Certificate of Appropriateness for 917 E Mifflin

March 11, 2019

Changes to Original Submittal

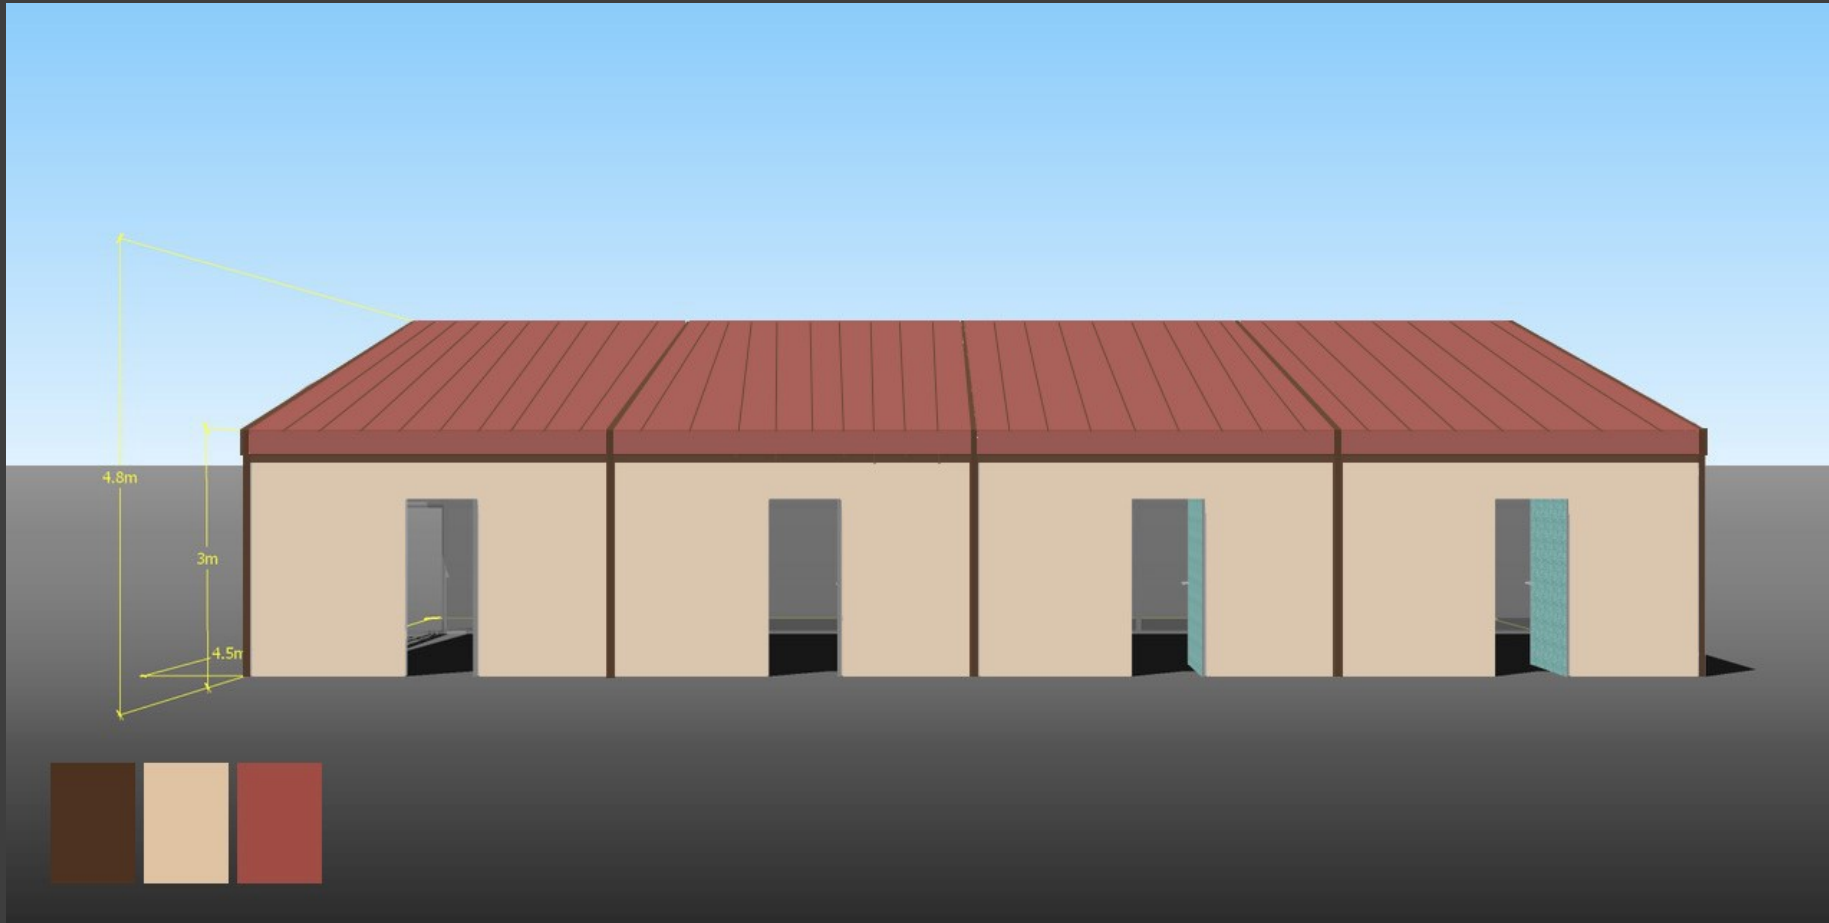
Staff recommendation for original submission was denial as the new structures were

1. Not in character with the other structures on the landmark property
2. Previous approvals were for structures that were either
 - a. Not visible from the street
 - b. Or unobtrusive
